Title: Cavalon Market Upgrade		
AG-SB-2021-06-C-EN	Effective Date: 19 Aug 2021	Compliance Category: A - MANDATORY B - RECOMMENDED C - OPTIONAL
Applicability		
Aircraft type & model: AutoGyro Cavalon	Affected Serial number(s): All AutoGyro Cavalon 912, 914 & 915iS	
The maintenance manual to be referenced is this stated or subsequent issue.		As per AutoGyro website
<p>This form is the response from AutoGyro GmbH either against a problem found in the product in service requiring a containment or rectification action, or as service information for aircraft modification incorporation. For help, contact airworthiness@auto-gyro.com.</p>

Reason and overview of the Service Bulletin (cause of problem if known)

Mast & head replacement

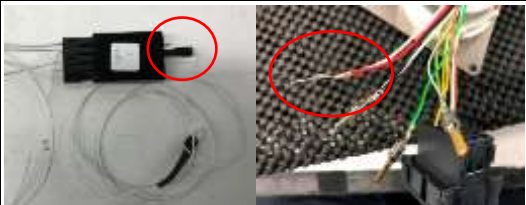
Ser	Description	Illustration
1	Remove the rotor system in accordance with AMM job card 62-11-00 4-1.	
2	Remove the mast fairing in accordance with AMM Job Card 52-00-00 4-1.	
3	Switch the flight/brake switch to flight.(if fitted with the latest generation electrically operated flight-brake switch, the key-switch must be temporarily active to do this) Remove the rotor head and top mast assembly in accordance with AMM job card 62-51-00 4-1.	
4	If the original pre-rotator shaft does not have a bearing retaining collar, it is strongly recommended that a new mod state shaft (32054) be fitted.	 <p>Bearing Retaining Collar</p>
5	It may be necessary to remove material from the composite web between mast rear face/brake-trim cylinder, and pre-rotator drive shaft bearing retaining plate. There must be a minimum of 3mm material visible forward of the forward edge of the drive shaft bearing retaining plate after any re-work.

Keel Tube I to II upgrade

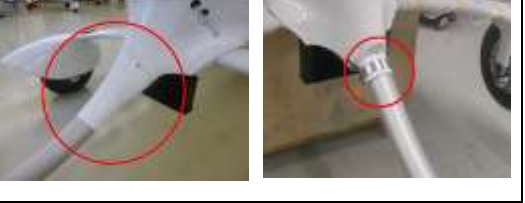
- 1 If the Cavalon is fitted with keel tube I (short version) it **MUST** be upgraded to keel tube II when upgrading from rotor head II to rotor head III.

Keel tube I – short (1671mm)

Keel tube II – long (1824mm)

- 2 Remove the left and right rudder control cable to rudder bolts
Note the position of washers and spacer when removing.

- 3 Supporting the rudder, remove the upper bolt, bush and washers.
Note the position of items for re-fitment.
Tilt the upper rudder slightly rearwards to clear the attachment bracket of the stabilizer, and slide upwards off of the lower bearing pin.

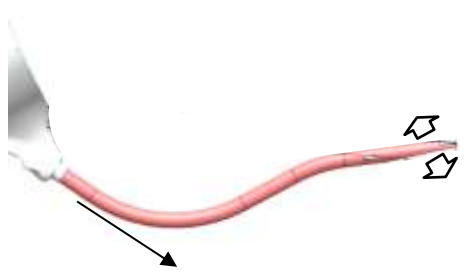
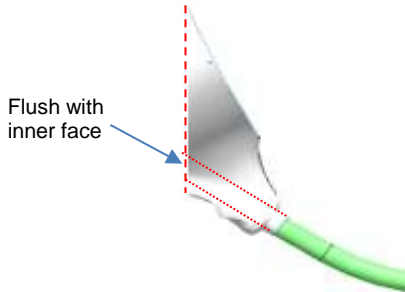
- 4 Remove the 4 horizontal stabilizer attachment bolts.
Note positions of spacers and washers.
Remove the stabilizer from the keel tube.

Teeter Tower III to III.1 upgrade
Removal of teeter tower and main crown gear assembly

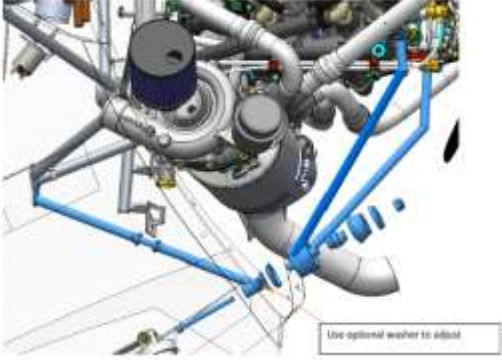
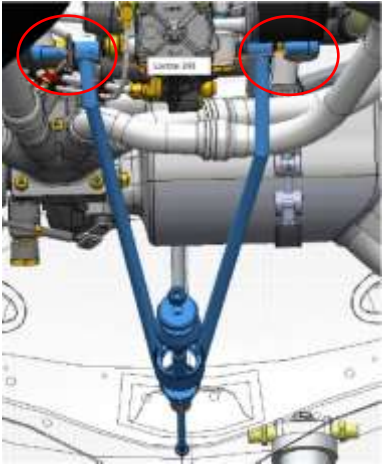
1	Remove the rotor system in accordance with AMM job card 62-11-00 4-1.	
2	Remove the teeter tower and main crown gear assembly in accordance with AMM job card 62-20-00 8-1.	
3	Remove the 10 countersunk screws from the main crown gear and remove the crown gear from the teeter tower.

4	Assemble the teeter tower III.1 to the main crown gear using 10 new M6x16 countersunk Torx and Loctite blue 243.	 <div data-bbox="1174 658 1430 707">Teeter Tower III.1</div>
5	Assemble the teeter tower and main crown gear assembly to the rotor head in accordance with AMM job card 62-20-00 8-1.	
6	Re-assemble the rotor system in accordance with AMM job card 62-11-00 4-1. Note: Teeter block III is compatible with both teeter tower III and teeter tower III.1.
